UNITED STATES PATENT AND TRADEMARK OFFICE

APPLICATION NO.	FILING DATE	FIRST NAMED INVENTOR	ATTORNEY DOCKET NO.	CONFIRMATION NO.
10/662,500	09/15/2003	Nathaniel Bair	67102-013	9191
26096 7590 08/23/2007 CARLSON, GASKEY & OLDS, P.C. 400 WEST MAPLE ROAD SUITE 350 BIRMINGHAM, MI 48009			EXAMINER THOMAS, COURTNEY D	
			ART UNIT 2882	PAPER NUMBER
			MAIL DATE 08/23/2007	DELIVERY MODE PAPER

Office Action Summary

DETAILED ACTION

Fig.4 – X-ray scanner – WO 9917659 to Virta et al.

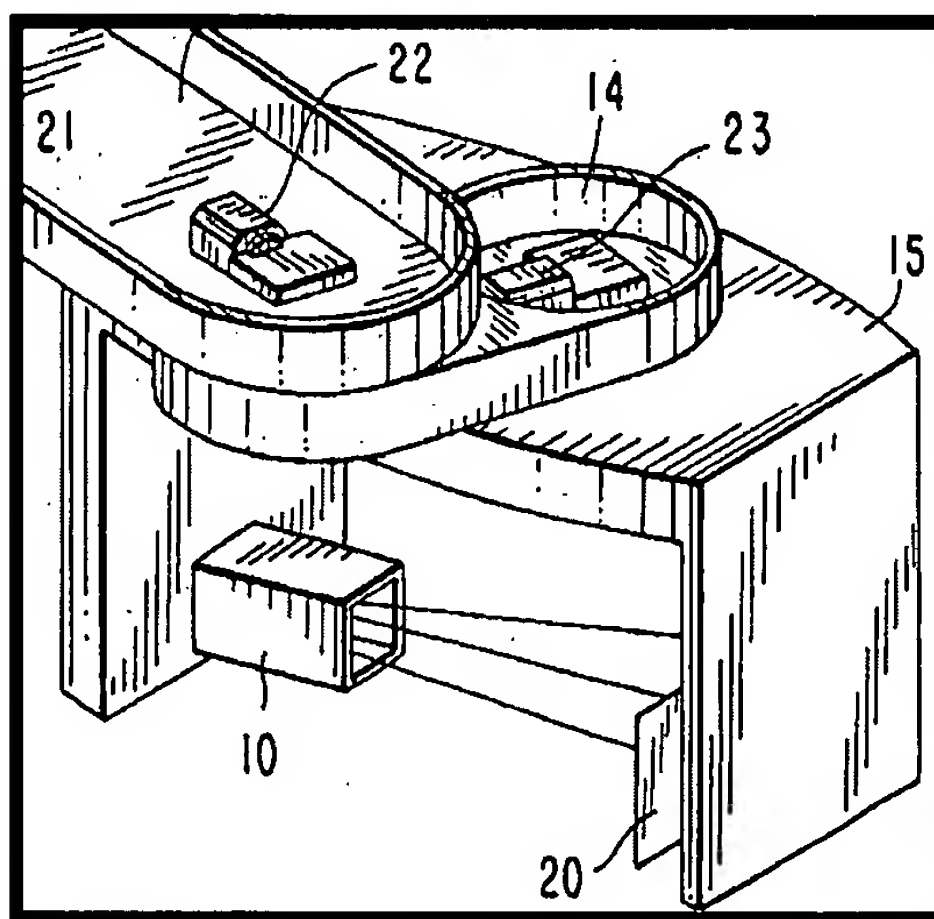
6. As per claims 1, 25, 33 and 34-39, Virta et al. disclose a computed tomography scanner (and corresponding method) comprising: a gantry (15); an X-ray source (10) mounted to the gantry; an X-ray detector (20) mounted to the gantry opposite the X-ray source (10); and a motor (23) mounted to the gantry. [Examiner note: see Figs. and respective portions of specification for additional apparatus details and methodology not shown above].

7. As per claim 2, Virta et al. disclose a computed tomography scanner comprising a mounting plate (14).

8. As per claims 12 and 13, Virta et al. disclose a computed tomography scanner wherein the gantry includes a housing in which the X-ray source (10) is at least partially mounted and wherein the source is a cone beam X-ray source (see Fig. 4 above).

Fig. 3 – X-ray scanner – U.S. Patent Application Publication 2001/0021244 to Suzuki et al.

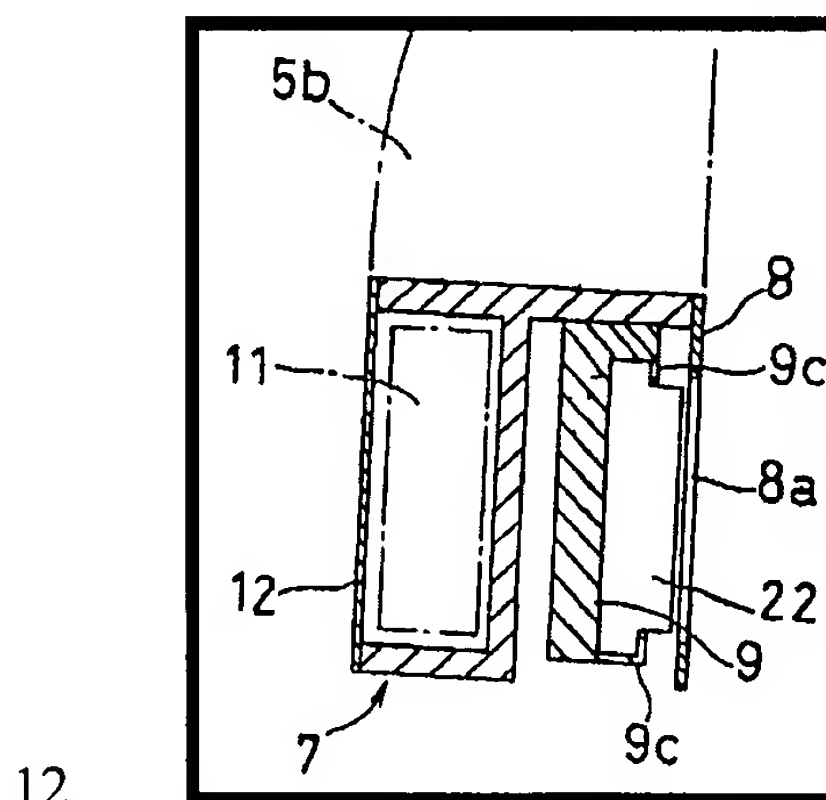
13. Suzuki et al. disclose a scanner including a computer (11) mounted on a gantry (5) such that the computer (11) rotates with the gantry (5) and sends signals the motor to control rotation of the gantry (para. [0098] - 11m - not shown above); controls the X-ray source (11d- not shown above) and processes images collected from the detector (11e – not shown above). Suzuki et al. teach that such construction provides a means of operating a scanner via the gantry.

16. Suzuki et al. disclose a scanner including a computer (11) mounted on a gantry (5) such that the computer (11) rotates with the gantry (5).
